**EXPLANATION OF SIGNIFICANT DIFFERENCES  
TO THE  
RECORD OF DECISION**

**OPERABLE UNITS 2 AND 9  
RUBBLE DISPOSAL AREA**

**NAVAL AIR STATION SOUTH WEYMOUTH  
WEYMOUTH, MASSACHUSETTS**

**REVIEW COMMENT SUMMARY and RESOLUTION FORM  
EAST-WEST PARKWAY AND RELATED IMPROVEMENTS**

SITE FEATURES  
 RUBBLE DISPOSAL AREA  
 LONG-TERM MONITORING ANNUAL REPORT - 2010  
 NAS SOUTH WEYMOUTH  
 WEYMOUTH, MASSACHUSETTS

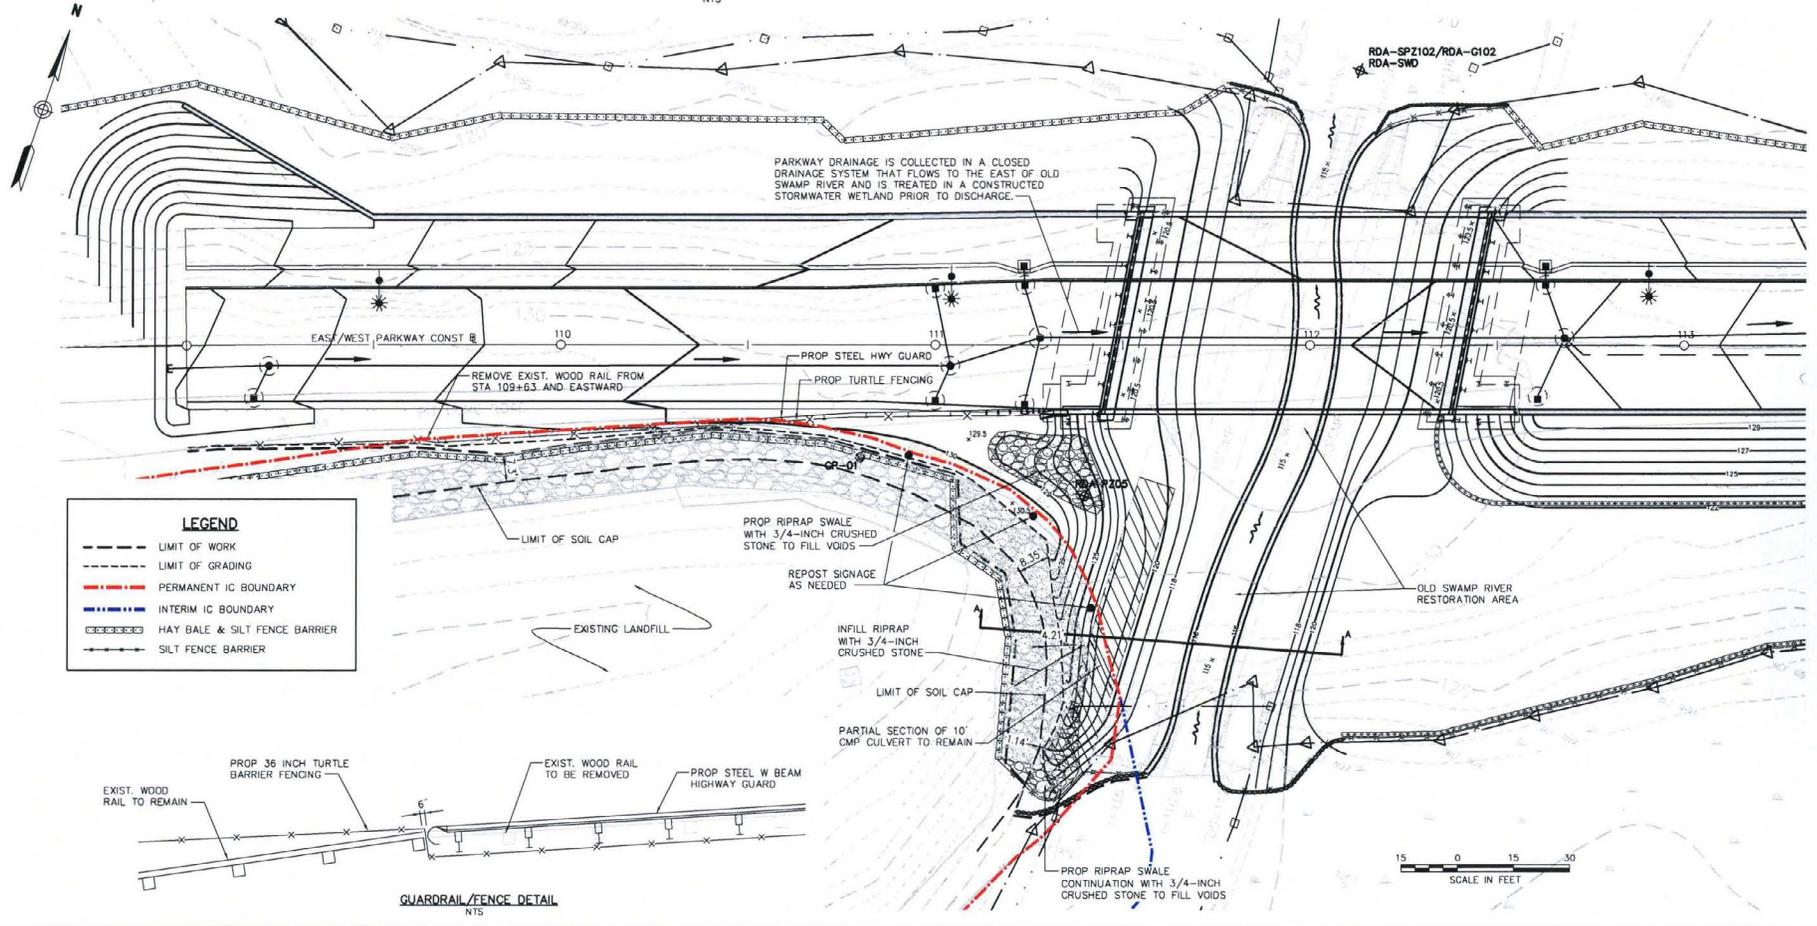
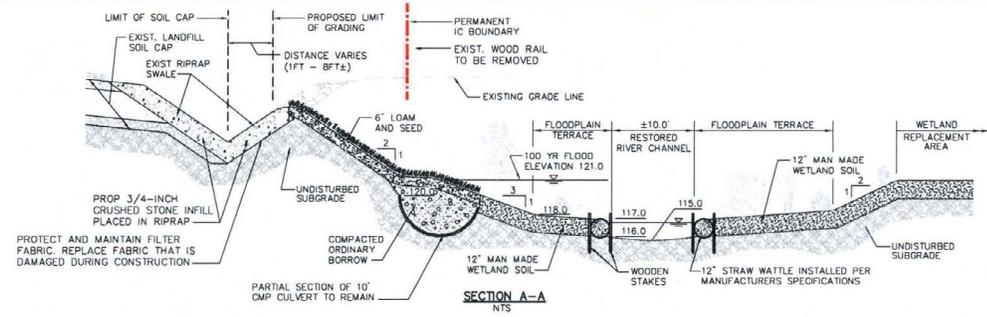
7	Sec AA	Why is the River Channel shown with a width of 10 feet? The river channel shown in the figure scales to 6 feet?	10 feet is the correct number. The figure was not drawn to scale. It has been revised to scale to the correct dimension.
<b>Joanne Marques: 60 Circuit Road, South Weymouth, MA 02190 – 12/9/11</b>			
1	-	Why isn't there a setback requirement associated with the construction of a major roadway abutting a capped hazardous waste landfill site?	The Navy's ROD selected institutional controls in the form of Land Use Controls as a component of the final remedy for the RDA to prohibit activities or uses of the site that would disturb or otherwise interfere with the integrity or effectiveness of the Cap. These Land Use Controls are contained in the Land Use Control Implementation Plan (October 2009). The LUCIP boundaries were established to ensure the effectiveness and integrity of the remedy. There is no further "setback" requirement from the LUCIP boundary. The Parkway is located outside of the LUCIP boundary.
